**Request for Additional Information No. 448(4898, 5084), Revision 0
Question 03.08.01-50, Revision 1**

U. S. EPR Standard Design Certification

SRP Section: 03.08.01 - Concrete Containment

Question 03.08.01-50:**Follow-up to RAI 155, Question 3.8.1-12**

Figure 03.08.01-50-1—Dimensions between Containment and Shield buildings at Ring Girder

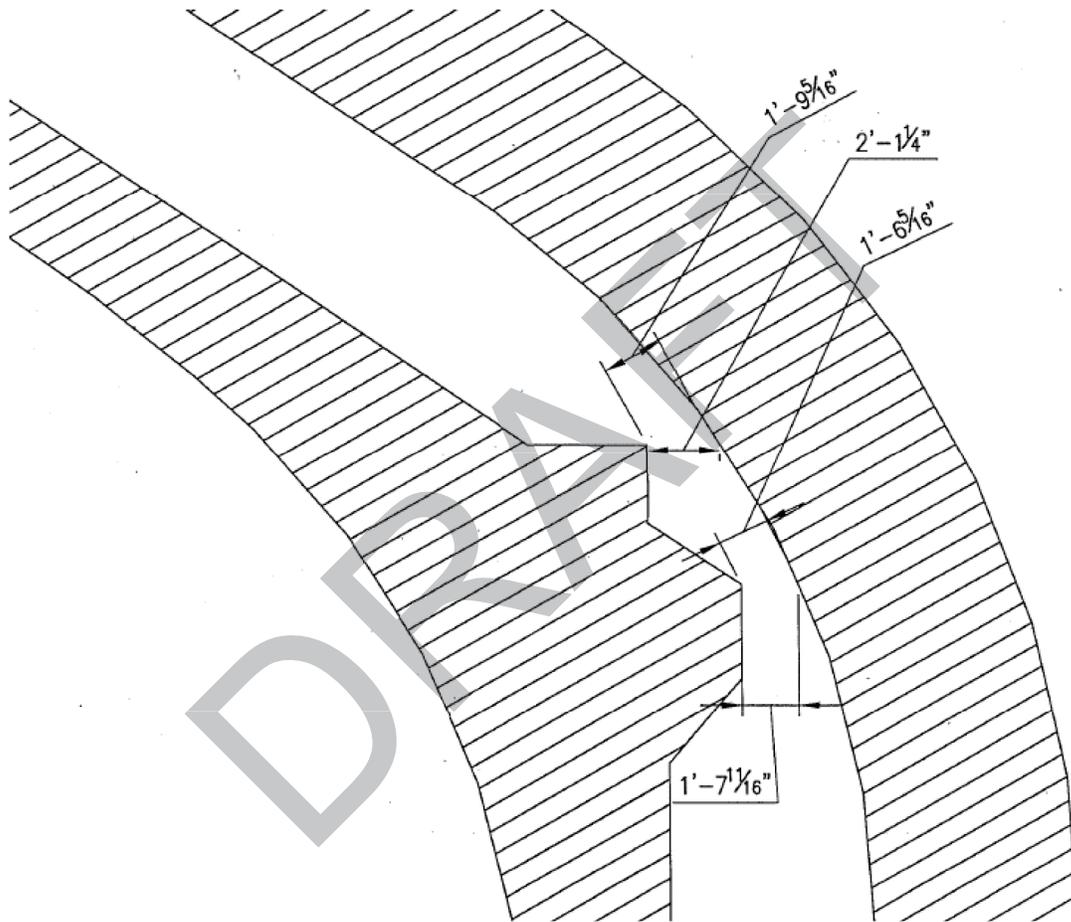
The response above gives insufficient technical justification for not providing force monitoring of ungrouted test tendons, as prescribed in RG 1.90. According to RG 1.90, the ISI program should consist of three distinct activities: (a) force monitoring of ungrouted test tendons; (b) periodic reading of instrumentation for determining prestress level (Alternative A) or monitoring of deformations under pressure (Alternative B) at preestablished sections; and (c) visual examination. Therefore, the deformation monitoring of the containment (item (b), Alternative B) does not eliminate the requirement to provide force monitoring of ungrouted test tendons (item (a)), but is an additional criterion of RG 1.90. Regarding Item (2)(c) in the above paragraph, explain how the acceptance by the NRC in two old NPPs for deformation monitoring of the containment during ISI tests demonstrates that monitoring of ungrouted tendons is not required. Regarding Item (2)(d) in the above paragraph, although the referenced paper reports an interesting case study where force monitoring was not used, the staff considers that it does not provide a technical basis for the exception taken to RG 1.90. Consequently, provide adequate technical justification, preferably supported by quantitative data, to demonstrate that ungrouted tendons are not needed.

Access to perform the visual inspections is provided from the tendon gallery, annular space between the containment building exterior wall and the reactor shield building wall, and the annular space between the containment building dome and reactor shield building dome shown in U.S. EPR FSAR Tier 2, Figure 3B-12. Figure 03.08.01-50-1 shows the dimensions of the space around the containment ring girder. There is approximately 18 inches between the containment ring girder and the Reactor Shield Building.
